MEETING AGENDA

HISTORIC DISTRICT REVIEW BOARD

Wednesday, September 11, 2024, 2:00 P.M.

**A. 1607 & 1609 Duke Street, PIN R120 003 000 0147 0000,
Applicant: Arnie McClure, Coast Architects, Inc.**

F1
A201
1607 - SOUTH ELEVATION
SCALE: 1/4" = 1'-0"

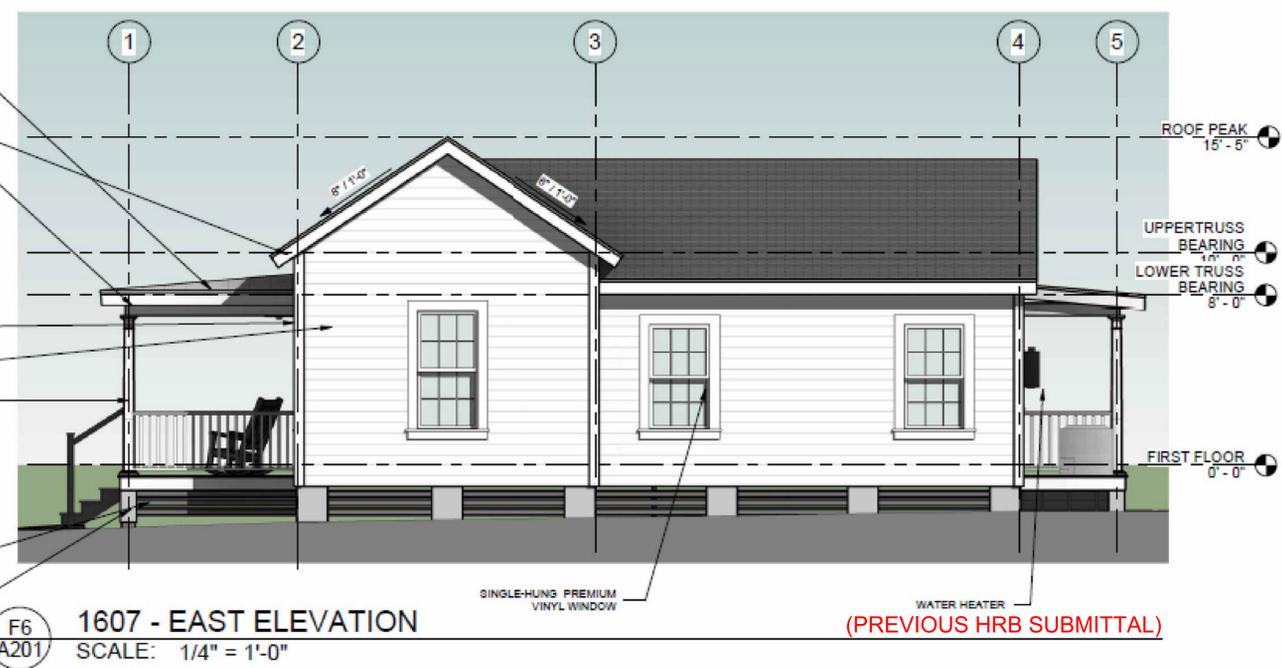
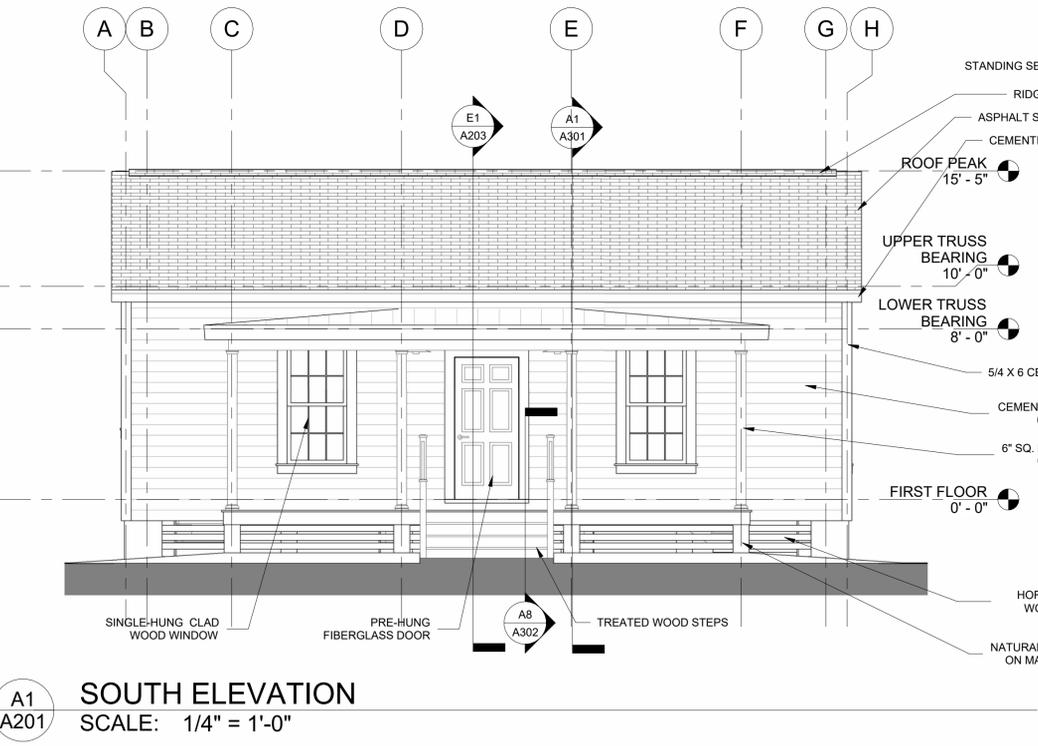
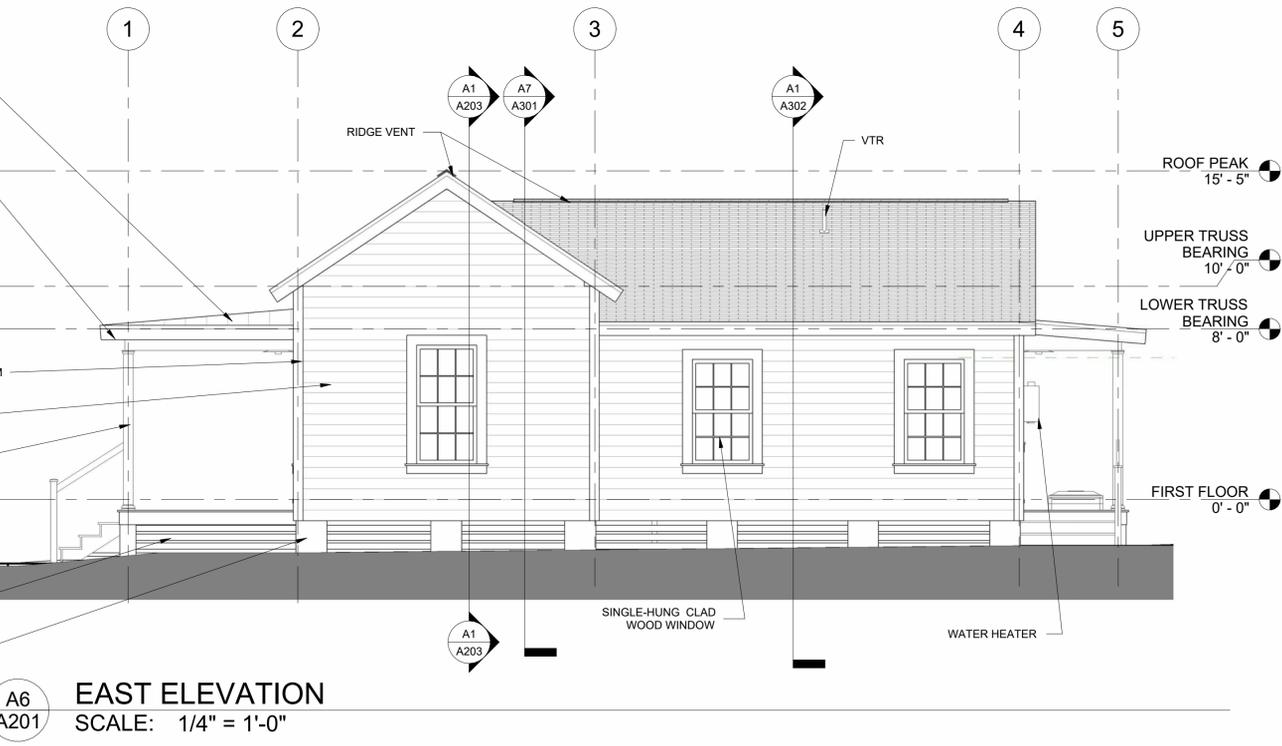
- Staff recommends the applicant revise the designs so that they are differentiated enough from the original structures, but still utilize elements found in historic Beaufort. Emphasis on the shed roof and changing wall planes.

- CHANGE VINYL WINDOWS TO ONES THAT MEET THE BEAUFORT PRESERVATION MANUAL STANDARD**
 PREFINISHED ALUMINUM CLAD DOUBLE-HUNG WINDOWS WITH SIMULATED DIVIDED LIGHTS (5/8" PUTTY PROFILE) HAVE BEEN SPECIFIED. BOTH HOUSES WILL BE PAINTED THE SAME WITH DIFFERENT ACCENT COLORS FOR THE DOORS.
- CONFIRM PLANS ARE IDENTICAL FOR BOTH STRUCTURES.**
 BOTH FLOOR PLANS ARE IDENTICAL EXCEPT ON THE REAR PORCH THE STEPS AND HVAC UNIT ARE MIRRORED TO ALLOW ACCESS TO PARKING SPOT.
- RECONSIDER CENTRAL ACCESS DRIVE AND CONFIGURATION.**
 THE GRAVEL DRIVE HAS BEEN DIVIDED INTO 2 SEPARATE DRIVES WITH A LANDSCAPE MEDIAN BETWEEN THEM.
- CONSIDER REMOVING REAR BALUSTRADES.**
 SINCE ALL PORCH FLOORS ARE LESS THAN 30" ABOVE THE ADJACENT GRADE, ALL GAURDRAILS HAVE BEEN REMOVED.
